From: Ramanauskas, Peter [/O=EXCHANGELABS/OU=EXCHANGE ADMINISTRATIVE GROUP (FYDIBOHF23SPDLT)/CN=RECIPIENTS/CN=6492DDC4240C482B891D9F48B06E17F6-PRAMANAU]
Sent: 3/27/2019 9:38:25 PM
To: Steven Klafka [sklafka@wingraengineering.com]
Subject: RE: Guidance for PCB Sampling under Bike Path

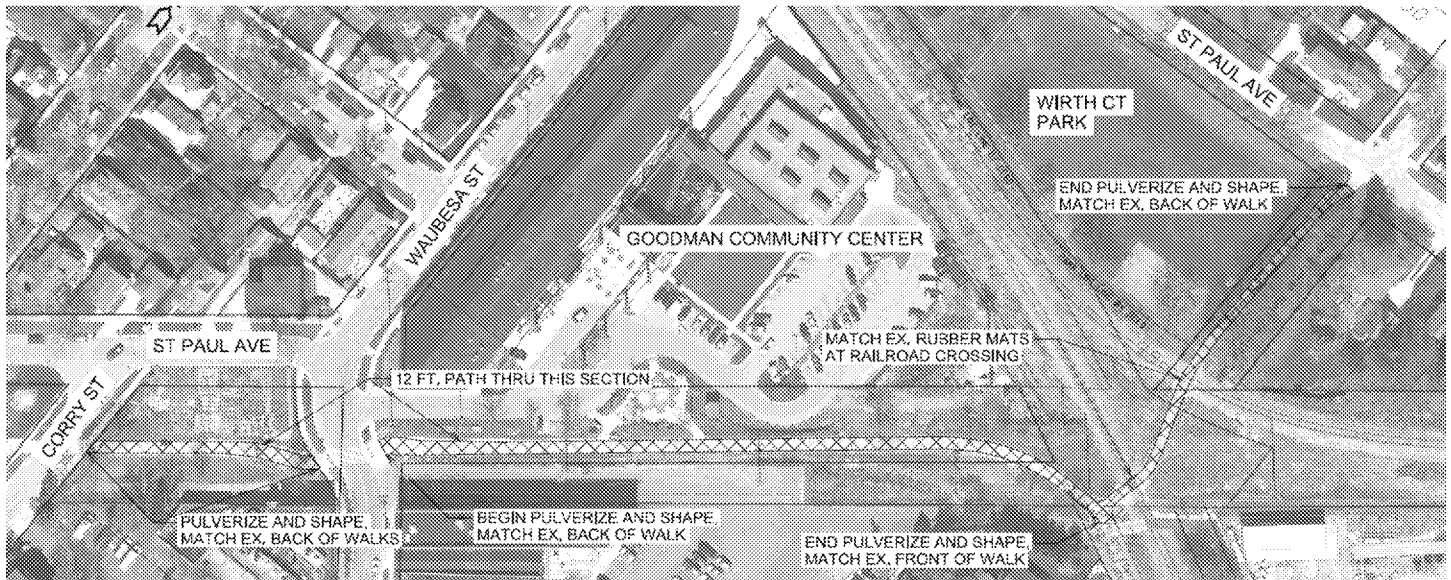
1. Is there EPA guidance on the frequency of sampling along the bike path? Their plan approved by the DNR calls for sampling every 93 feet. Sampling in the soil adjacent to the bike path found orders of magnitude difference just within a few feet.

2. The bike path is a highly used and is immediately next to the Goodman Center which has outdoor toddler splash pad, pre-school and 4-year old kindergarden. Should the residential RCL of 0.2 ppm be used to determine if soil should be removed rather than the 10 ppm approved by the DNR?

The federal regulations provide a characterization guidance under 40 CFR 761 Subpart N; however, it is not mandatory for use. Project Managers are able to use professional judgement related to the adequacy of site characterization based on site specific conditions.

Under the federal PCB regulations, 10 ppm is an acceptable cleanup level for areas meeting a high-occupancy use if the residual PCB between 1 and 10 ppm is capped and noted within an institutional control for the property.
